**ADDENDUM NO. 01 – PORTAGE PUBLIC SCHOOLS – HAVERHILL ELEMENTARY SCHOOL BP 6:
CONSTRUCTION**

ADDENDUM NO. 1 (BP 6)

DATE OF ISSUANCE:	July 26, 2023
PROJECT:	Haverhill Elementary School Bid Package 6: Construction 6633 Haverhill Avenue Portage, MI 49024
OWNER:	Portage Public Schools
ARCHITECT'S PROJECT NO.:	21-237.20
ORIGINAL BID ISSUE DATE:	June 30, 2023

1 GATHERING STAIR PARTIAL PLAN
 1/4" = 1'-0"

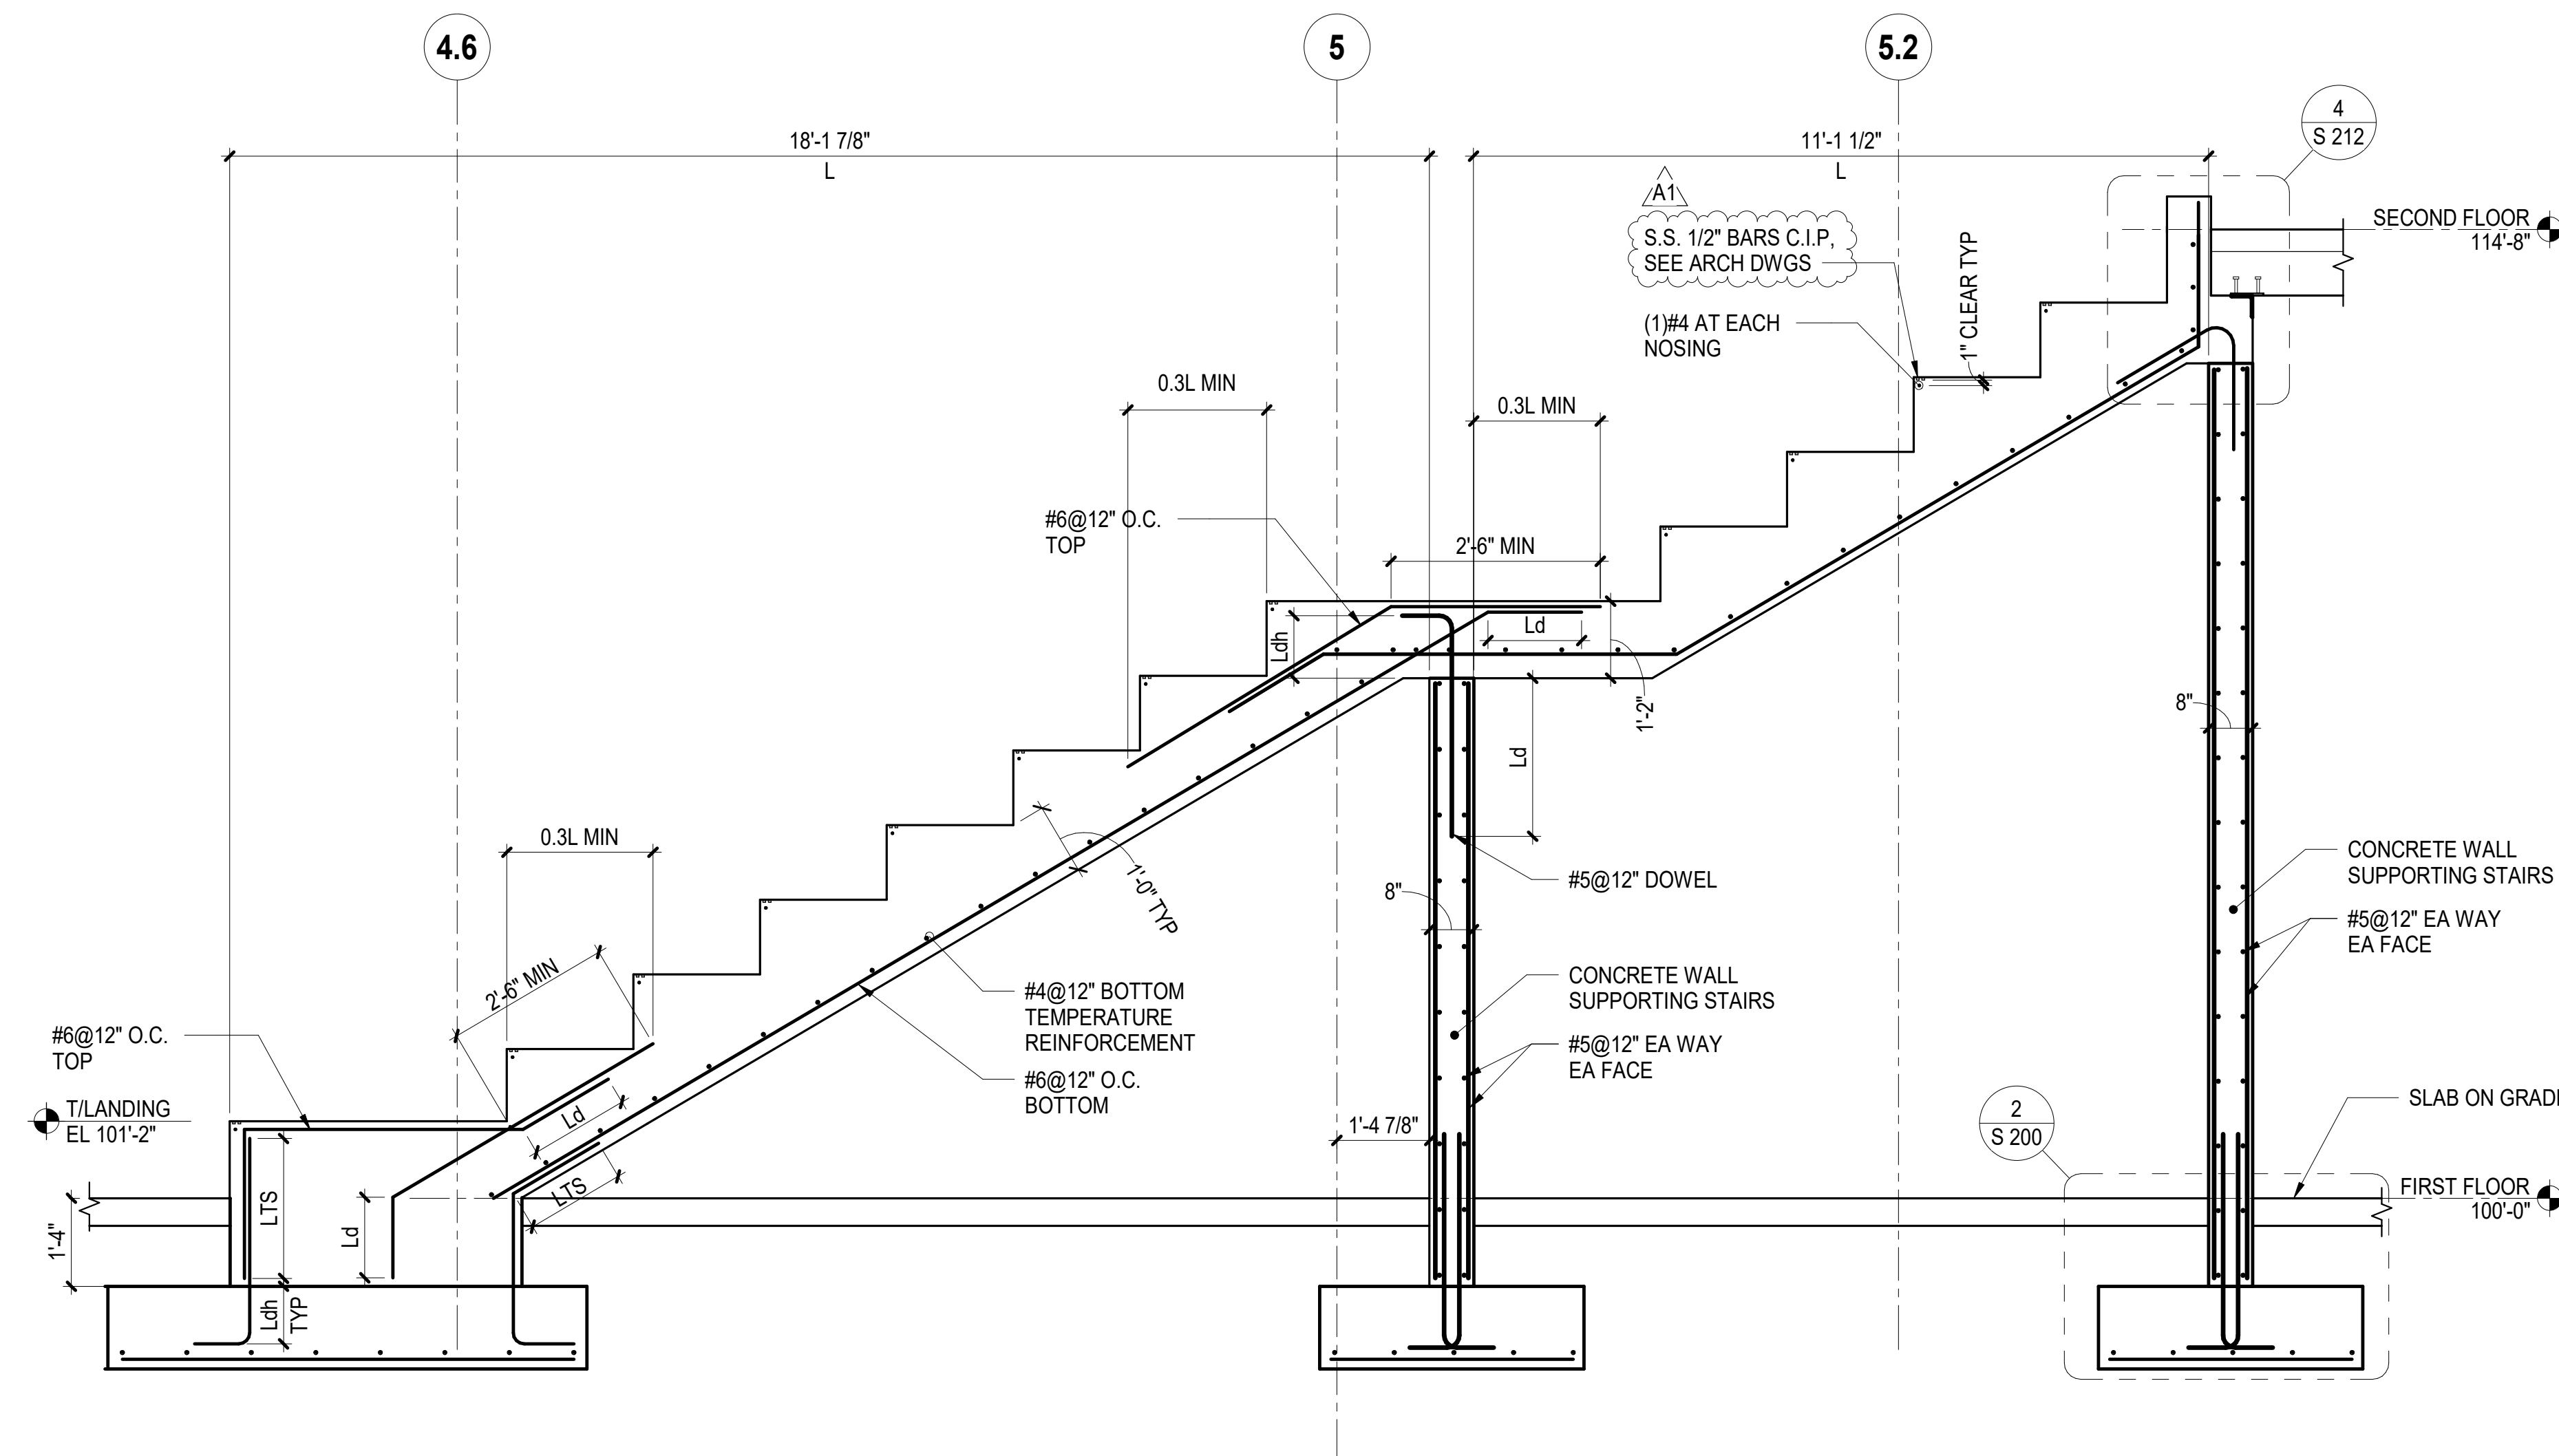
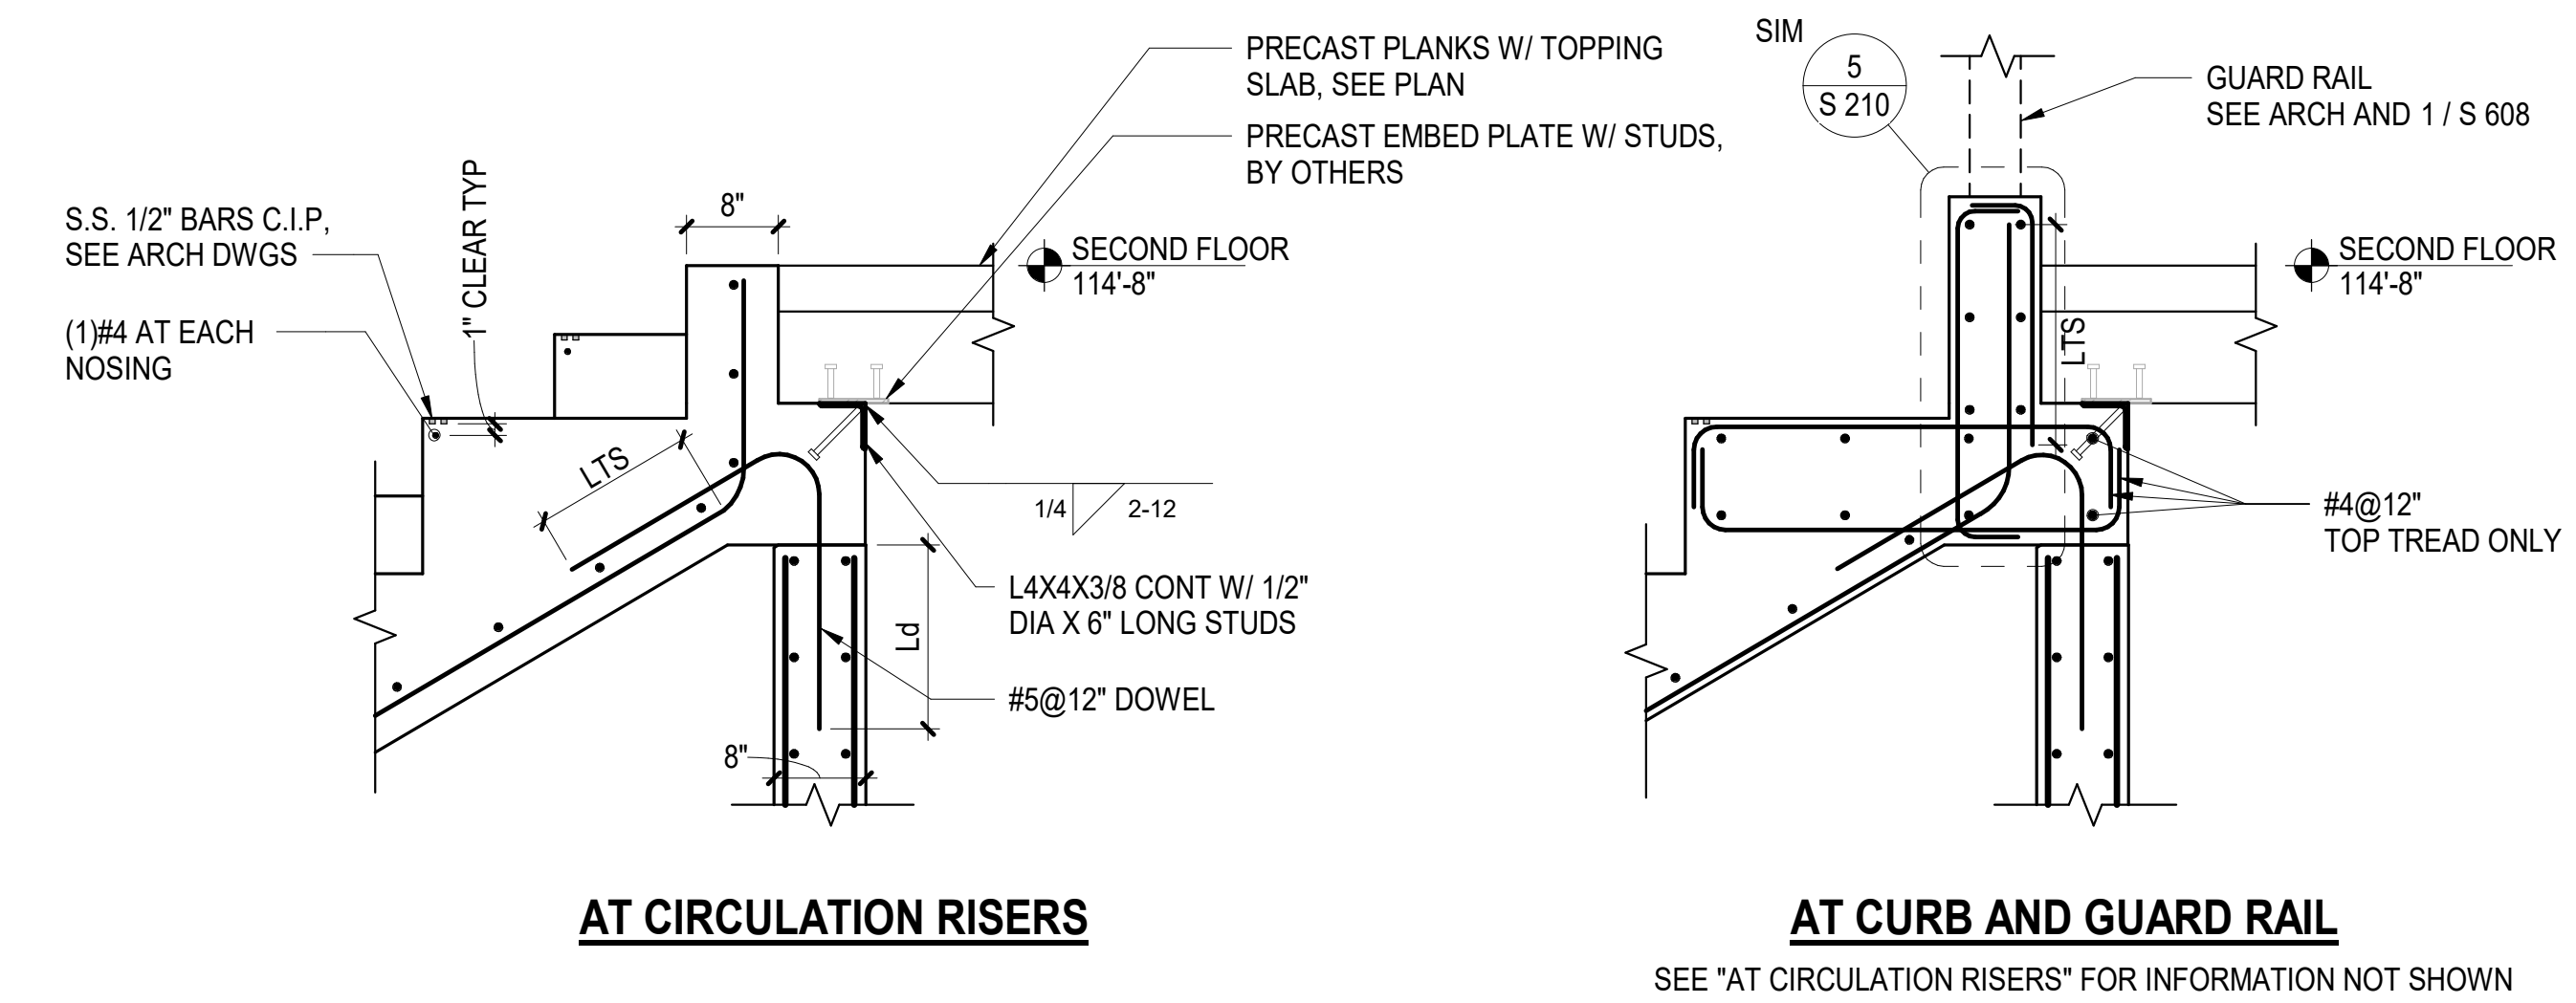
Added stair nosings per architectural drawings
